ADELL CENTER PRO JZ18-24 with Rezoning 18.724

ADELL CENTER PRO JZ 18-24 AND ZONING MAP AMENDMENT 18.724

Consideration at the request of Orville Properties, LLC for a Zoning Map Amendment 18.724 for Planning Commission's recommendation to City Council for a Planned Rezoning Overlay Concept Plan (PRO) associated with a zoning map amendment, to rezone from Expo (EXPO) to TC (Town Center). The subject property is approximately 21.48 acres and is located at 43700 Expo Center Drive, north of Grand River Avenue and south of I-96 in Section 15. The applicant is proposing to develop the property as a multi-unit commercial development consisting of nine units accessed by a proposed private drive. The current PRO Concept plan includes a request for an Unlisted Use Determination under Section 4.87 of the Zoning Ordinance.

REVISED PRO CONCEPT PLAN

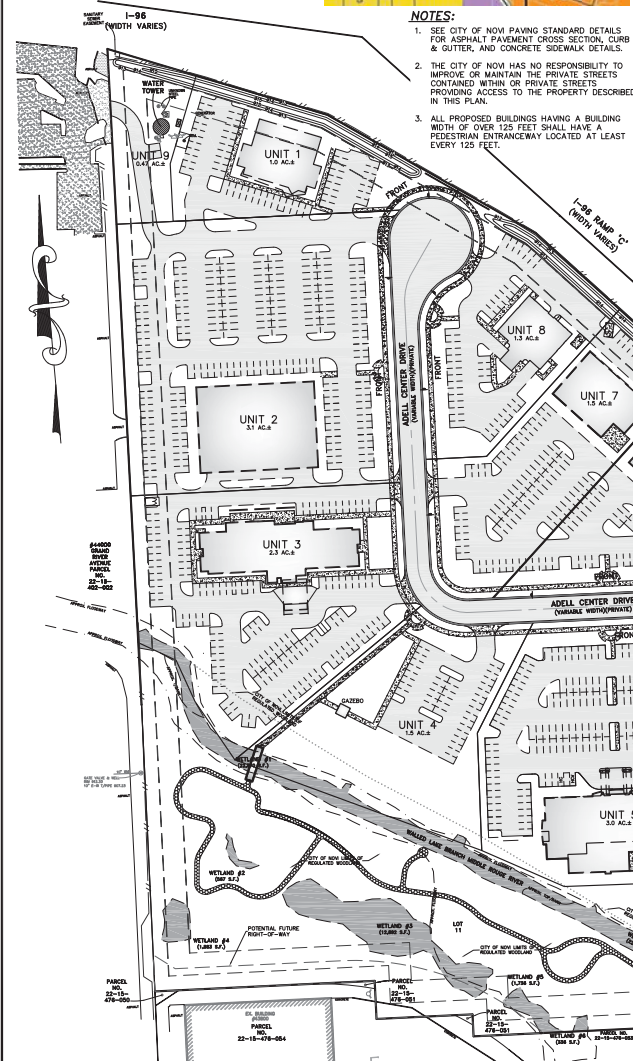
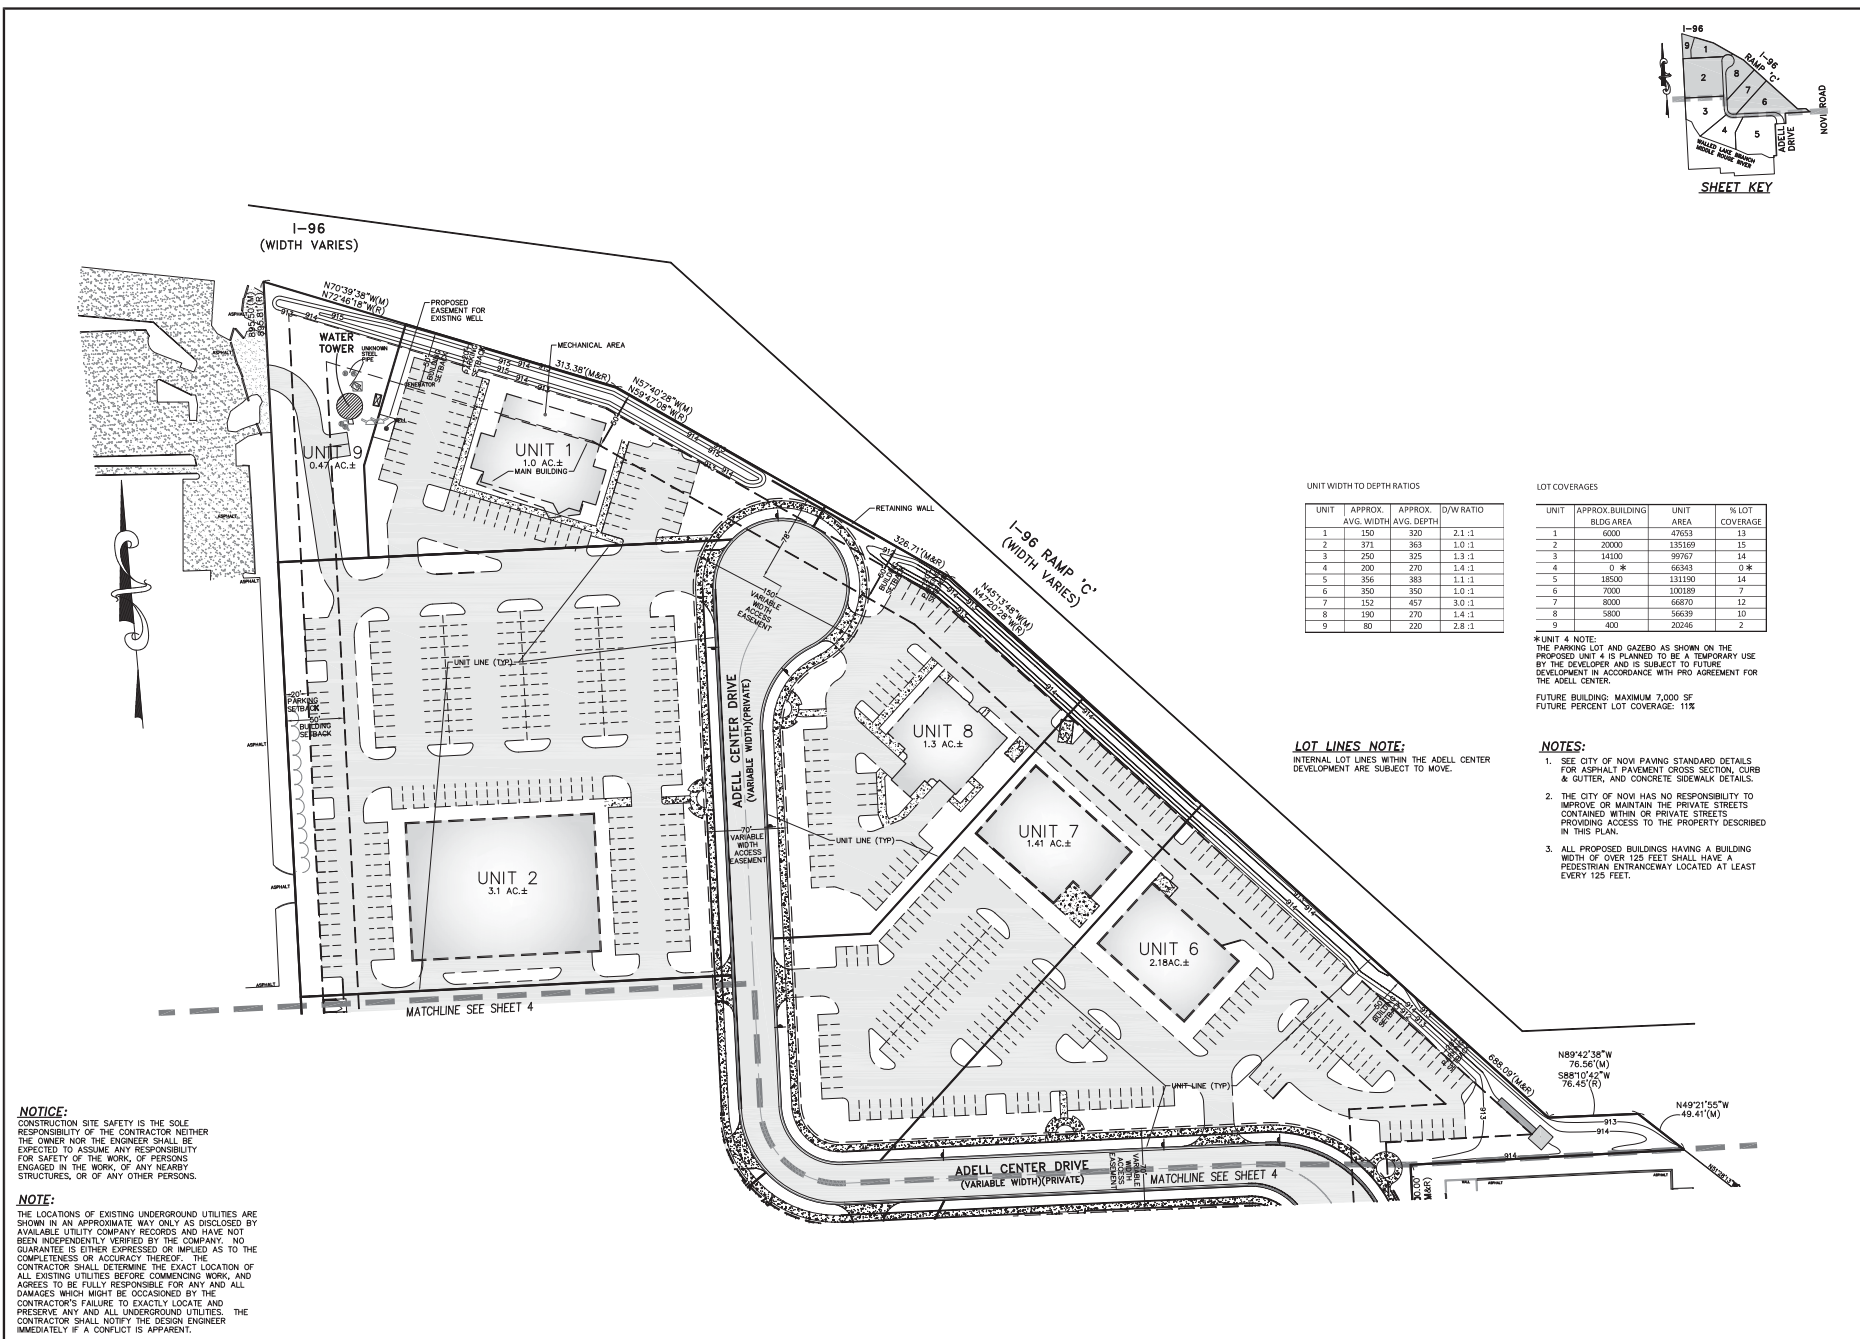
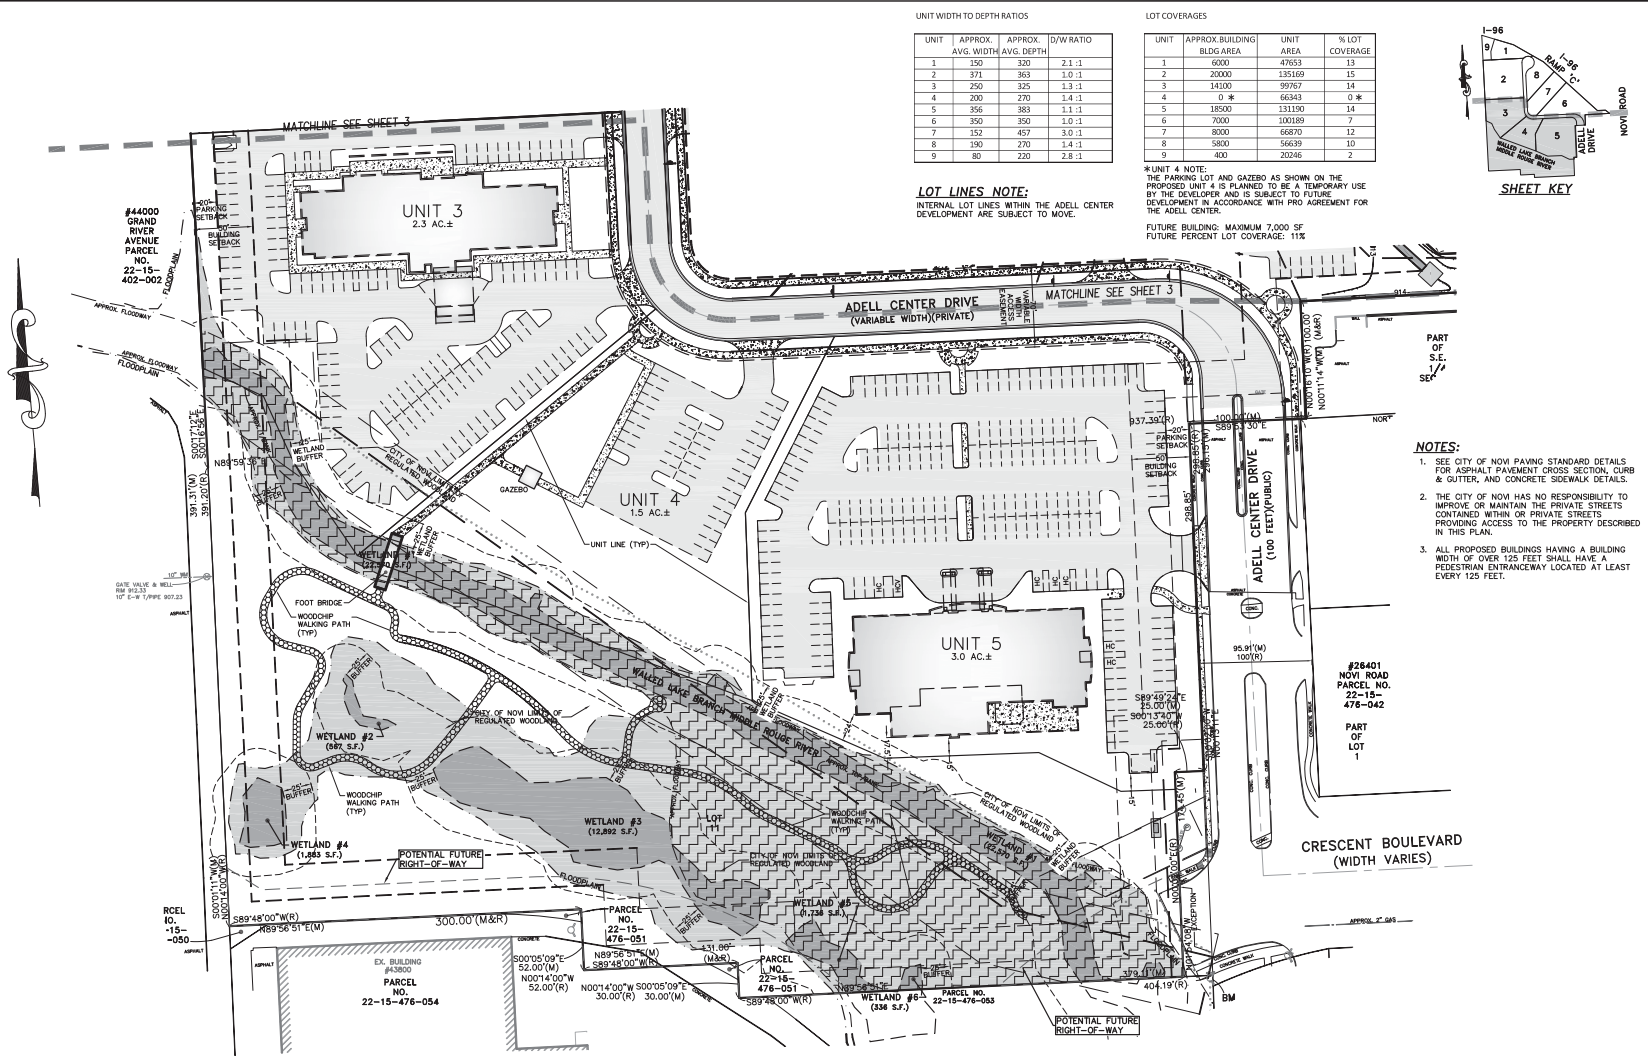
4. The applicant shall provide a secondary access point to the parking lot for Unit 5;
5. Sheet 2 states that the proposed building and parking lot layouts are conceptual only. This is not consistent with the Concept Plan as submitted. This note shall be removed; Any notes that refer to the Concept Plan as subject to change at the time of Preliminary Site Plan approval shall be removed from all plans;

4. **ALLOWABLE USES FOR FUTURE DEVELOPMENT:** List of suggested allowable uses provided by the applicant on sheet 2, should be revised to address the following:

- Medical offices and laboratories is a not a permitted use under TC district. This item should be removed
 - Last two bullet points on sheet 2 that references to other uses and accessory structures should be removed.

8. **PRO CONCEPT PLAN:** Sheet 2 states that the proposed building and parking lot layouts are conceptual only. This does not meet the intent of PRO Concept plan. **This note must be removed.** Development and use of the property shall be subject to the more restrictive requirements shown or specified on the PRO Plan. **The applicant should note that the following would possibly require an amendment to the PRO Agreement, unless otherwise agreed upon:**

Sheet 2 states that the proposed building and parking lot layouts are conceptual only. This does not meet the intent of PRO Concept plan. **This note should be removed.** As stated above, development and use of the property shall be subject to the more restrictive requirements shown or specified on the PRO Plan. The applicant should note, any major deviations from the approved PRO plan would possibly require an amendment to the PRO plan.

8. **PRO CONCEPT PLAN:** Sheet 2 states that the proposed building and parking lot layouts are conceptual only. This does not meet the intent of PRO Concept plan. **This note must be removed.** This note will be removed and replaced with a note that states "The proposed buildings and parking lot layouts are preliminary and subject to final site plan approval per the City of Novi TC zoning district and the Adell Center PRO Development Agreement". Development and use of the property shall be subject to the more restrictive requirements shown or specified on the PRO Plan. The applicant should note that the following would possibly require an amendment to the PRO Agreement, unless otherwise agreed upon:

Sheet 2 states that the proposed building and parking lot layouts are conceptual only. This does not meet the intent of PRO Concept plan. **This note should be removed.** *This note will be removed and replaced with a note that states "The proposed buildings and parking lot layouts are preliminary and subject to final site plan approval per the City of Novi TC zoning district and the Adell Center PRO Development Agreement".* As stated above, development and use of the property shall be subject to the more restrictive requirements shown or specified on the PRO Plan. The applicant should note, any major deviations from the approved PRO plan would possibly require an amendment to the PRO plan.

ADELL CENTER OPEN SPACE PLAN

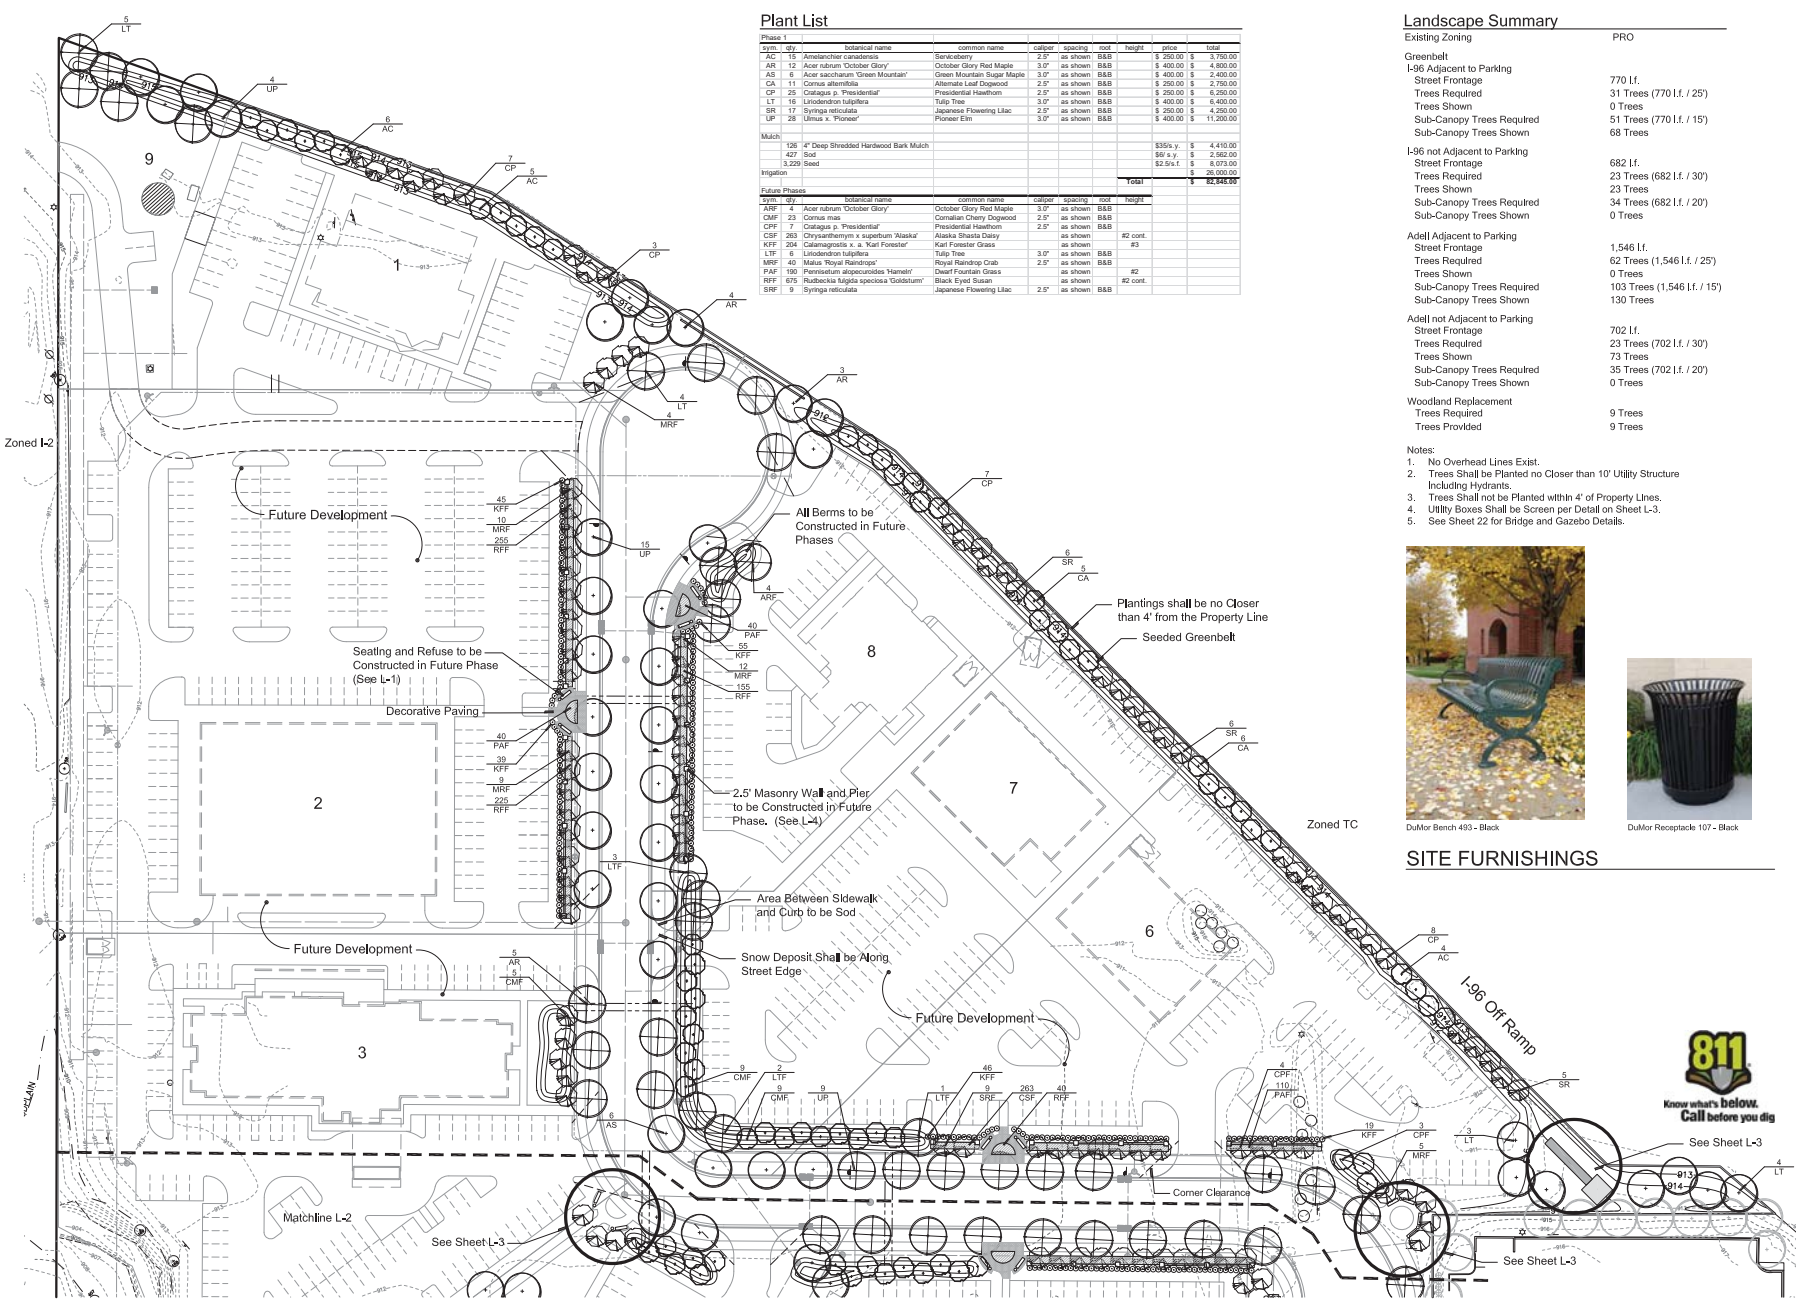
7. The Open space plan (Sheet 19) proposes the required open spaces on Unit 6, Unit 4, end of the cul-de-sac and south side of the Middle Rouge River. The southerly area contains about an acre of wetlands that account for about 25 percent of the open area. The southern area of the site contains a large quantity of undesirable, invasive plant and shrub species located in the wetlands and woodland areas as well as refuse and debris generally located along the banks of the Walled Lake Branch. The applicant shall provide a proposed restoration/site enhancement plan that addresses these items in order to provide for a more usable and aesthetic open Space area for the development as indicated in the response letter. It is not clear whether the buyers of the proposed units will agree to provide and maintain the open space as shown on the open space plan;

5. **OPEN SPACE AND RESTORATION PLAN:** The Open Space Plan (Sheet 19) proposes the required open spaces on Unit 6, Unit 4, end of the cul-de-sac and south side of the Middle Rouge River. The southerly area contains about an acre of wetlands that account for about 25 percent of the open area. The southern area of the site contains a large quantity of undesirable, invasive plant and shrub species located in the wetlands and woodland areas as well as refuse and debris generally located along the banks of the Walled Lake Branch. The applicant should consider providing a proposed restoration/site enhancement plan that addresses these items in order to provide for a more usable and aesthetic Open Space area for the development.

5. **OPEN SPACE AND RESTORATION PLAN:** The Open Space Plan (Sheet 19) proposes the required open spaces on Unit 6, Unit 4, end of the cul-de-sac and south side of the Middle Rouge River. The southerly area contains about an acre of wetlands that account for about 25 percent of the open area. The southern area of the site contains a large quantity of undesirable, invasive plant and shrub species located in the wetlands and woodland areas as well as refuse and debris generally located along the banks of the Walled Lake Branch. The applicant should consider providing a proposed restoration/site enhancement plan that addresses these items in order to provide for a more usable and aesthetic Open Space area for the development. **The applicant will submit a wetland enhancement plan as part of the final site plan approval process.**

Figure 1. City of Novi Regulated Wetland & Woodland Map (approximate parcel boundary shown in orange). Regulated Woodland areas are shown in green and Regulated Wetland areas are shown in blue.

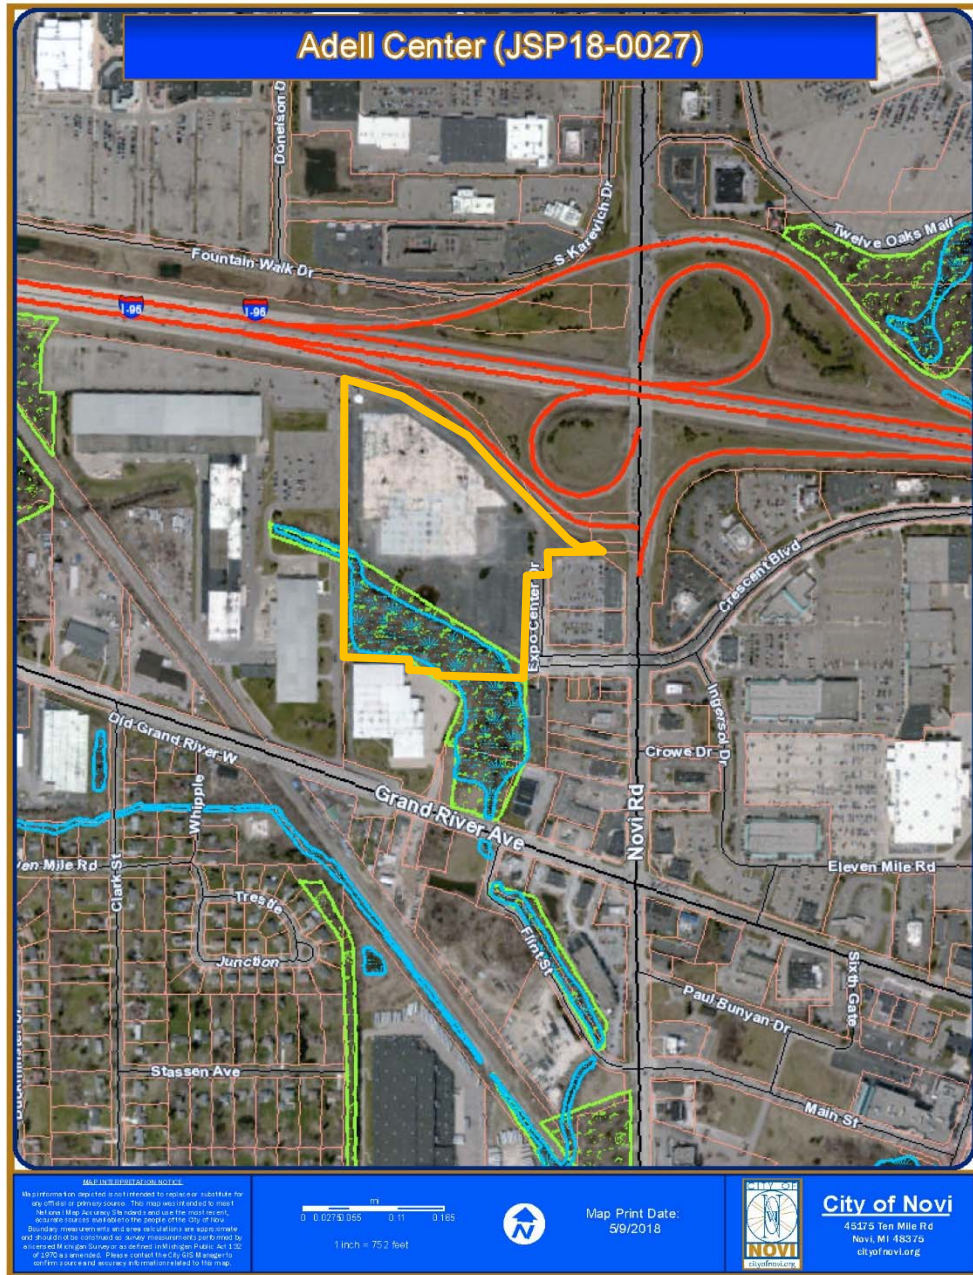
All six (6) of the on-site wetlands appear to be located within the area depicted as regulated wetland on the City of Novi Regulated Wetland and Watercourse Map (Figure 2). ECT has evaluated each wetland and believes that each wetland is regulated by the City's Wetland and Watercourse Protection Ordinance because all on-site wetlands are located within 500-feet of the Walled Lake Branch of the Middle Rouge River.
